TP-LINK CORPORATION PTE.LTD.

Subject: Requesting Class II permissive change for FCC ID: 2BCGWF65WALL

The purpose of this letter is to request a Class II Permissive change for FCC ID: 2BCGWF65WALL, original granted on 03/29/2024.

Sub-board schematic:

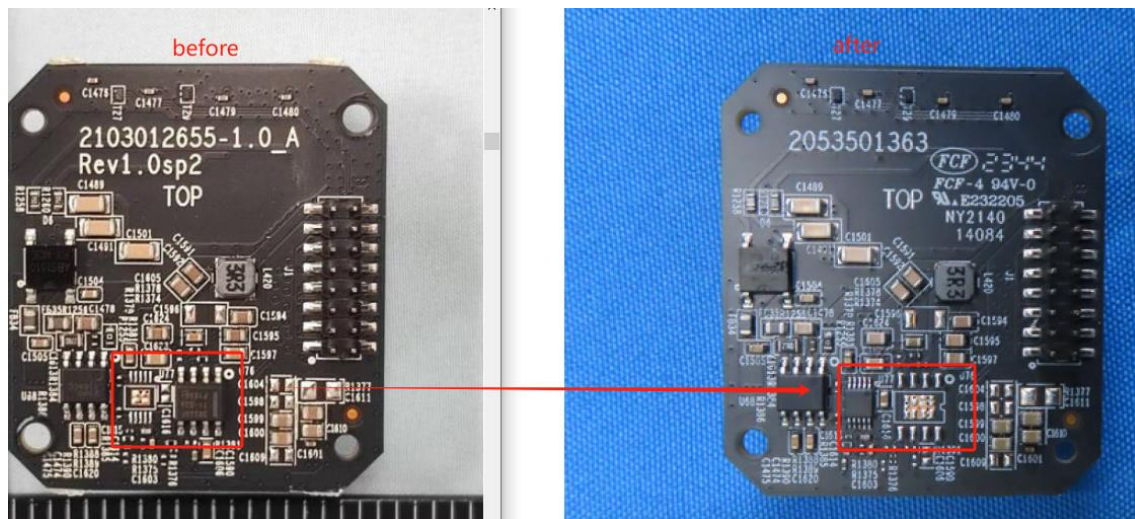
- 1) Change P02 block diagram transformer to UTG24P05, change DC-DC to SCT2620.

Motherboard schematic:

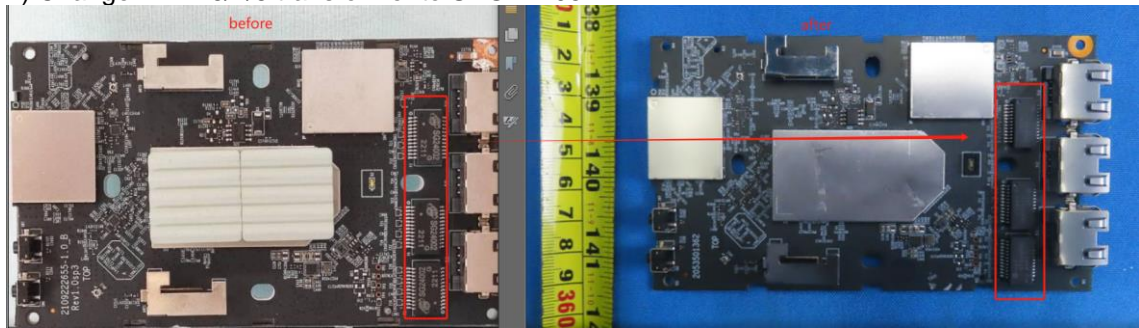
- 1) Change P02 block diagram transformer to UTG24P05, change DC-DC to SCT2620

2) Change P12 T6/7/8 transformer to UTG24P05
